SUBJECT: ISSUANCE OF AMENDMENT NO. 24 TO FACILITY OPERATING LICENSE
NO. R-84 ARMED FORCES RADIOBIOLOGY RESEARCH INSTITUTE
RESEARCH REACTOR (TAC NO. MB2296)

AMENDMENT TO FACILITY OPERATING LICENSE

Amendment No. 24
Licensee No. R-84

**TECHNICAL SPECIFICATIONS FOR THE
AFRRI REACTOR FACILITY**

Figure 1. Organization of Personnel for Management and Operation of the AFRRRI Reactor Facility

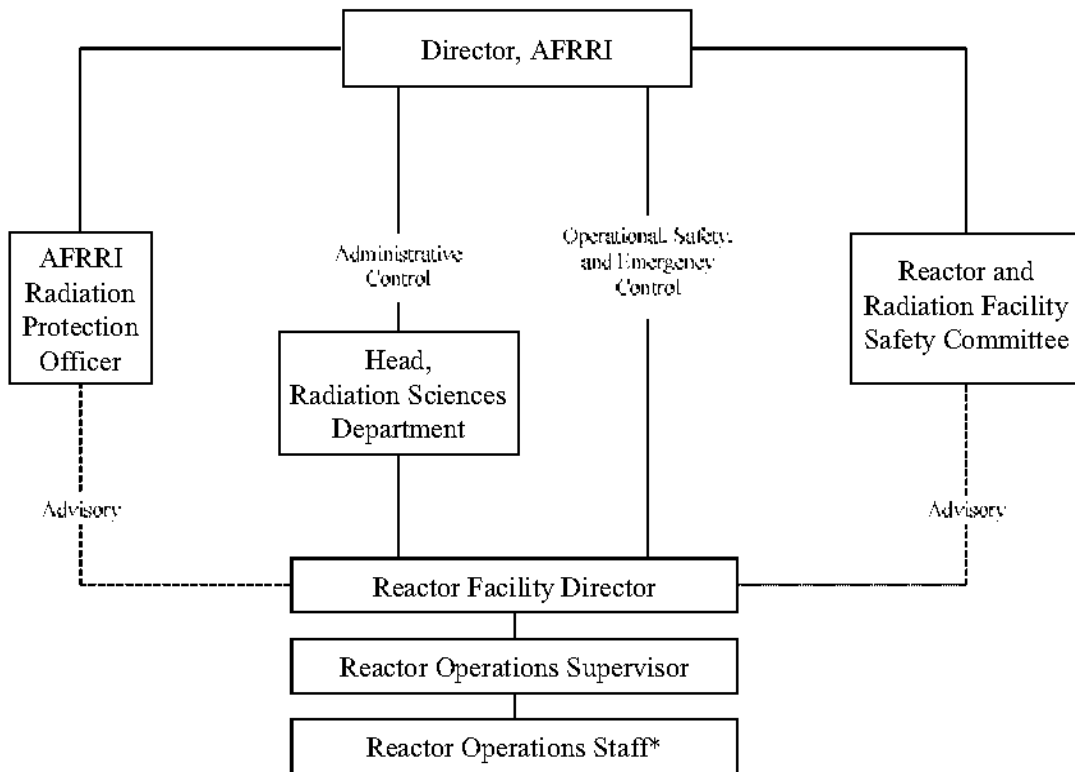
The licensee proposed an organization name change from "Radiation Sources Department" to "Radiation Sciences Department." This administrative change is to be consistent with licensee usage. The change does not affect function of other licensee's organization. Therefore, the NRC staff finds this change acceptable.
